date June 26, 1985

from D. A. Powers, 6422

subject Consultant's Report on the ACRS Subcommittee on Air Systems Meeting June 17, 1985, Washington, D.C.

FIGURE 1 - TYPICAL SOURCE TERM DESCRIPTION OBTAINED FROM MODERN MECHANISTIC PROCEDURES

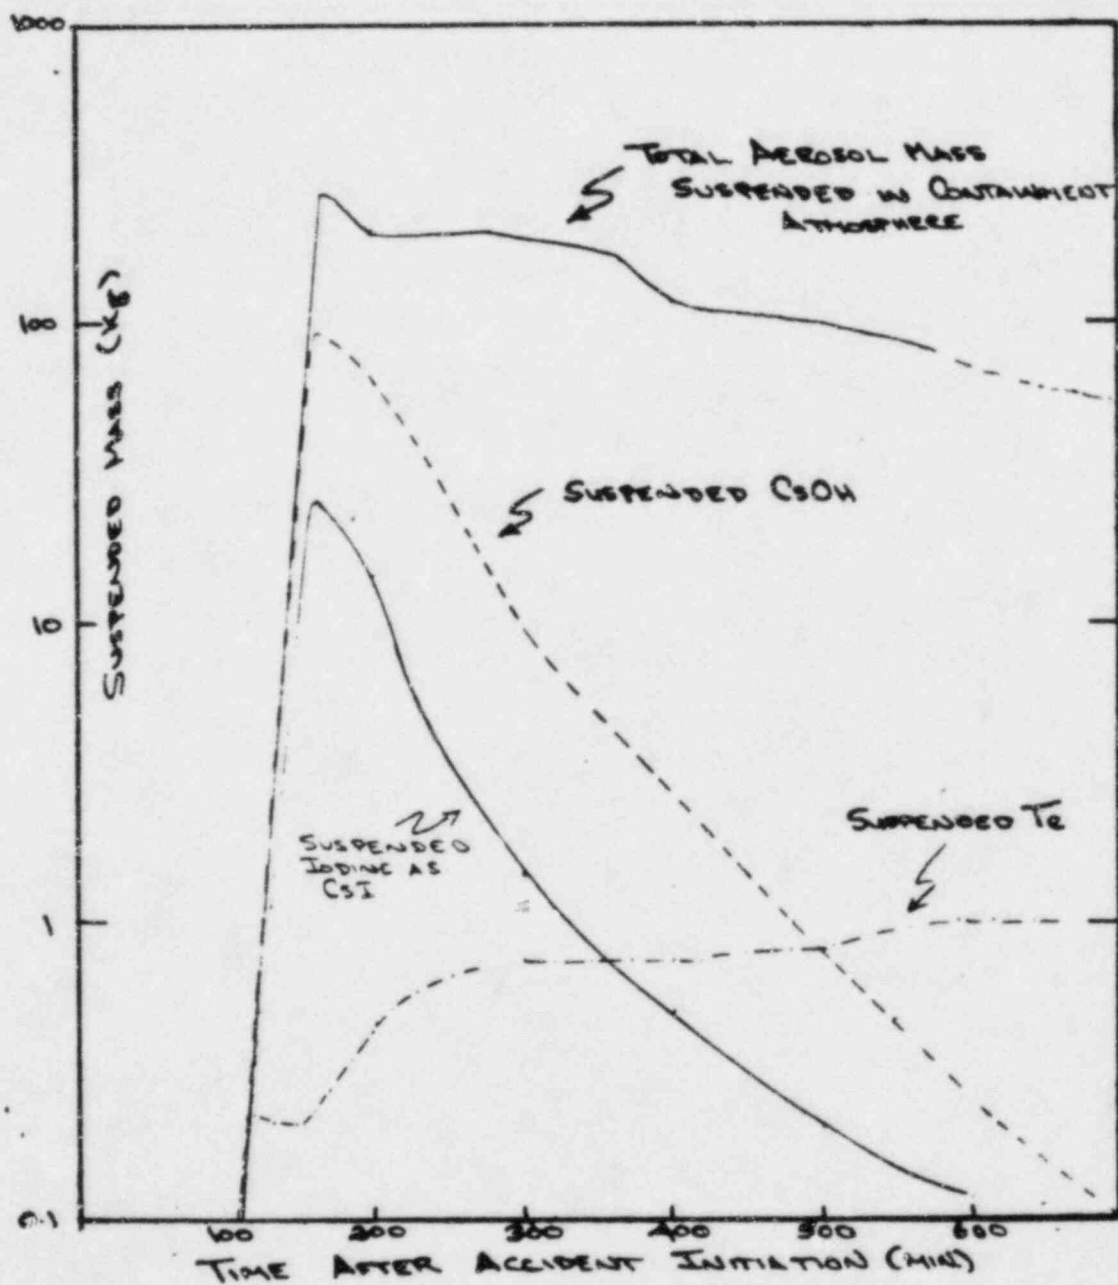
An example of modern calculated source terms is shown in Figure 1. The amount of material suspended in the containment atmosphere is shown in this figure as a function of time. Also shown are curves that indicate the cesium, iodine, and tellurium content of the suspended material. Cesium and iodine inventories are very strong functions of time. These materials are released from the fuel quite early in an accident. Aerosols composed of cesium and iodine (in the form of iodides) have an opportunity to agglomerate and settle in the containment if there is not a significant breach in the containment. This settling process sharply reduces the releaseable amounts of cesium and iodine. Tellurium suspended in the containment is a less sensitive function of time. Aerosols composed of tellurium or tellurides ( $\text{Ag}_2\text{Te}$ ,  $\text{FeTe}$ , etc.) engage in the same sort of processes that reduce so sharply the inventory of releaseable cesium and iodine. But, the tellurium in the containment atmosphere is being continuously replenished by releases from the core debris as it interacts with concrete in the reactor cavity. The weak dependence on time of the total aerosol inventory in containment also arises because of the replenishment of aerosols from core debris/concrete interactions.

The source term description shown in Figure 1 is that to which control rooms will be exposed only if a breach or major leak path is formed in the reactor containment. The

The revised source has some consequences on design of filtration system. The most obvious consequence is that HEPA filters unprotected by some sort of pre-filter are threatened. HEPA filters are very easily overloaded especially if the atmosphere is contaminated by the masses of aerosol material shown in Figure 1. When overloaded, HEPA filters fail. The next consequence is that activated charcoal will not efficiently getter the radiological threat posed by the new source term. Charcoal beds are poor traps for aerosols and will not getter iodine in the form of iodides.
